PROPOSED CHANGE NO. SC-01-001

Date: July 11, 2025
File: 9.1.7.4.2_SC-01_PC
Project No.: 2215C
Project: TA Blakelock HS Reno - Phase 3
Subcontract: SC-01 General

Description: *Sump pit floor door*

HATCH FT-8050 36 X 36 ALUMINUM W/SPRINGS, SLAMLOCK, BIT. PAINT & 1" RECESS FOR TILE

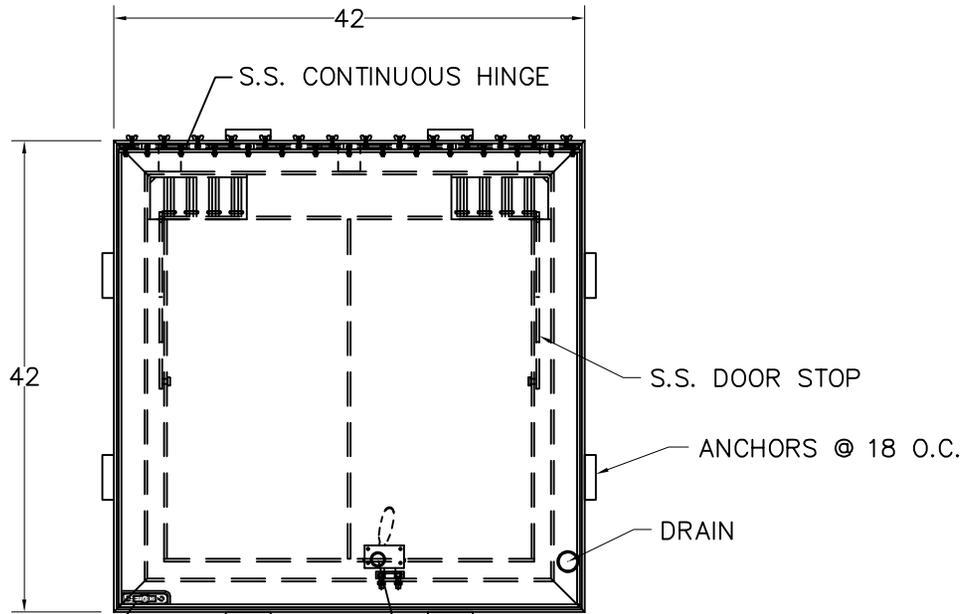
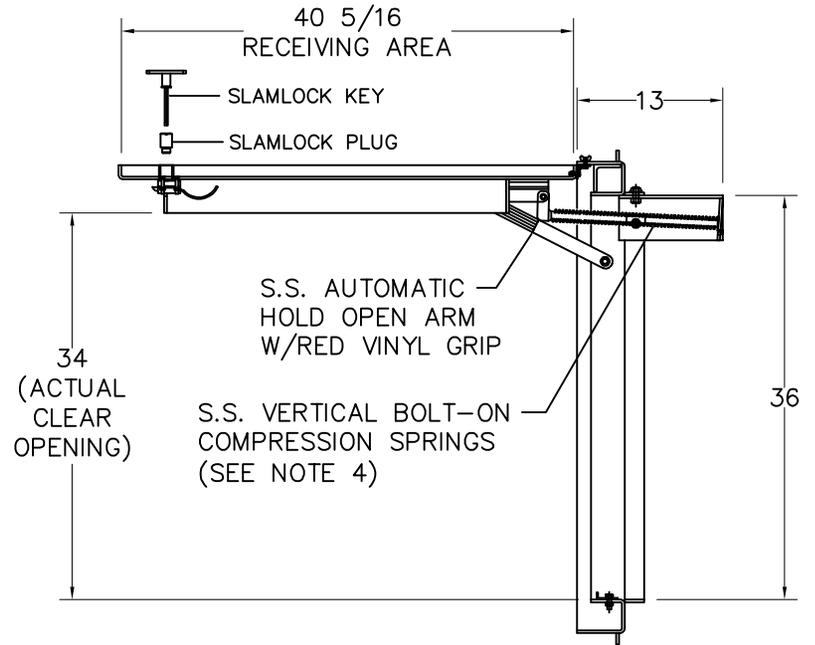
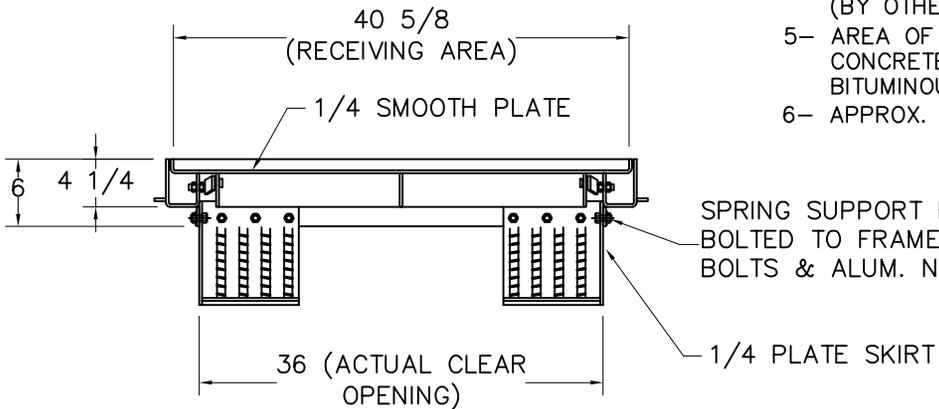
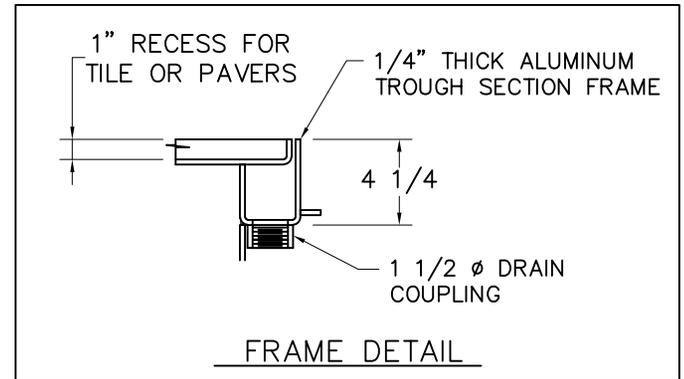
1. Provide quote for attached 36" x 36" Acudor, this would provide 28" dia. clearance for removal of sump pit cover. Confirm lead time.
2. Acudor to receive adjacent tile finish. Purpose of issuance of this PC at this stage alone from the rest of sump pit location requirements is to confirm lead time and price.

FT-8050

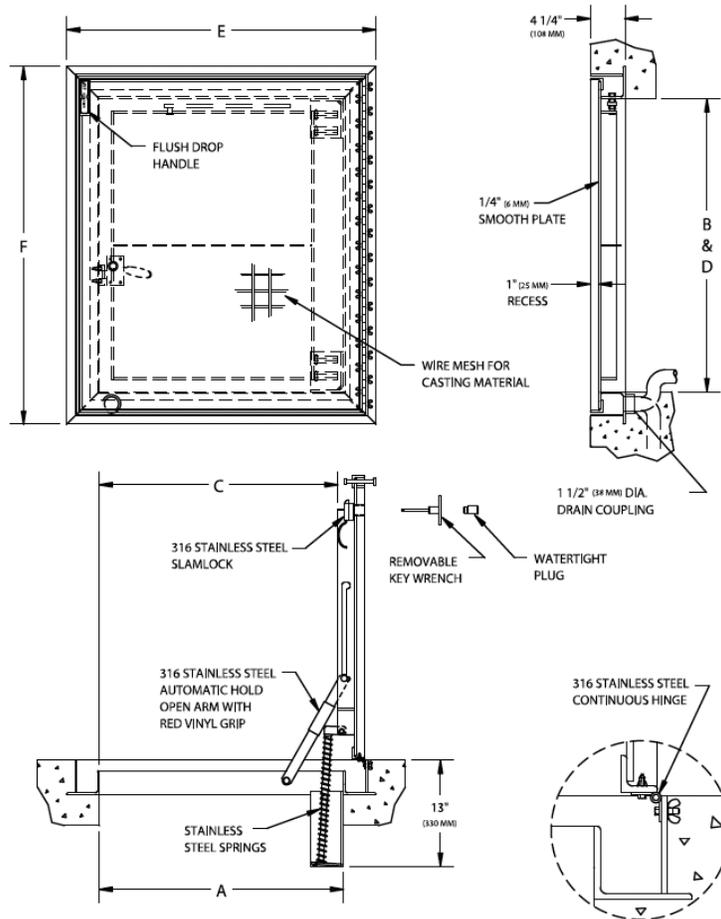
Thank you Frank what is the actual available clearance on the 36 inch. where nothing interferes with removal from what's below.

Hi Frank we will be specifying one of your FT-8050 1" recessed for ceramic tile concrete floor doors.
This door is going over top of a sump pit cover that is 28" in dia. Please confirm which model below will allow this to happen.
Is it the 36"x36"? While the C dimension is shown below this does not tell me if the clear opening is obstructed by the springle flange.
Please call if easier to discuss. Please ignore the red outline below.

It would be 34" clear opening .

Eng. confirmed that a 36" x 36" size door would provide 28" dia. clearance for removal of sump pit cover.
